330 Church Street, Parramatta (MP10_0171 MOD 4)

Attachment 1

Attachment 2 – Apartments Requiring Modification

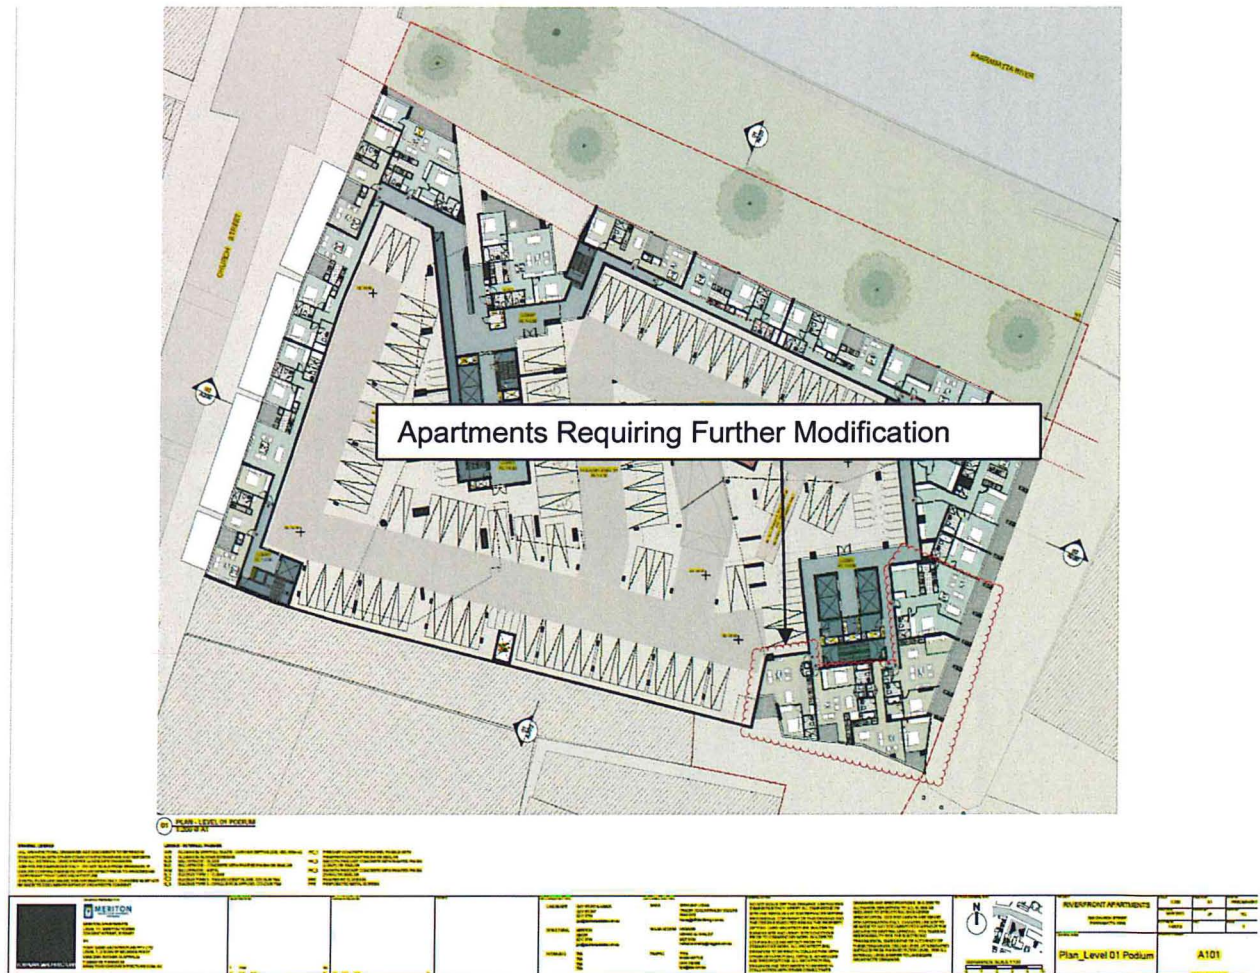
In addition, the department has identified a number of apartments within the podium levels that do not achieve an appropriate level of amenity as articulated in SEPP 65. In this regard, the architectural plans for the podium level apartments should be revised to:

- Improve solar access and ventilation along the internal corridors;
- Provide reduced travel distances and a direct line of sight to the entry of each apartment from the access points proposed on each level;
- Remove the enclosed study rooms proposed in south and east facing apartments; and
- Reconfigure the apartments located on the south-east corner of the podium to reduce the length of the internal corridor and improve the access arrangements to the adjoining balconies. In this regard, it is the department's preference that the apartments identified in the plan provided at **Attachment 2** are consolidated to provide a higher level of amenity.
